**Photo Report**  
**Lower Scholl Canyon Park**  
**Programs, Services, and Activities**

17-Jul-07

**Finding:** The Lower Scholl Canyon Park, located at 2849 East Glenoaks in Glendale California, was inspected by Disability Access Consultants, Inc., on June 12, 2007.

***Men's Restroom***

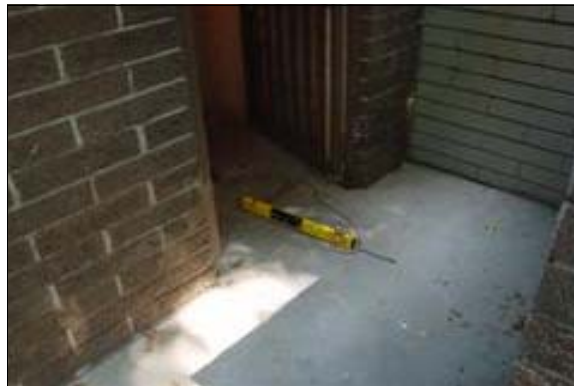
**Finding:** There is no signage indicating accessibility on the latch side of the entry door of the restroom. There is no Title 24 gender use signage on the entrance door.

**Full Rec:** The restroom is designated accessible and should be made accessible for the facility. Post signage centered 60 inches above the ground surface on the latch side of the entrance door identifying the restroom as accessible upon completion of the following items (see CBC 1115B., ADAAG 4.1.2(7) and ADAAG 4.1.6(3)(e). Signage shall include Braille and raised lettering, the gender or unisex use symbol and the ISA symbol. Post Title 24 gender use signage on the door @ 60" o.c. a.f.f.
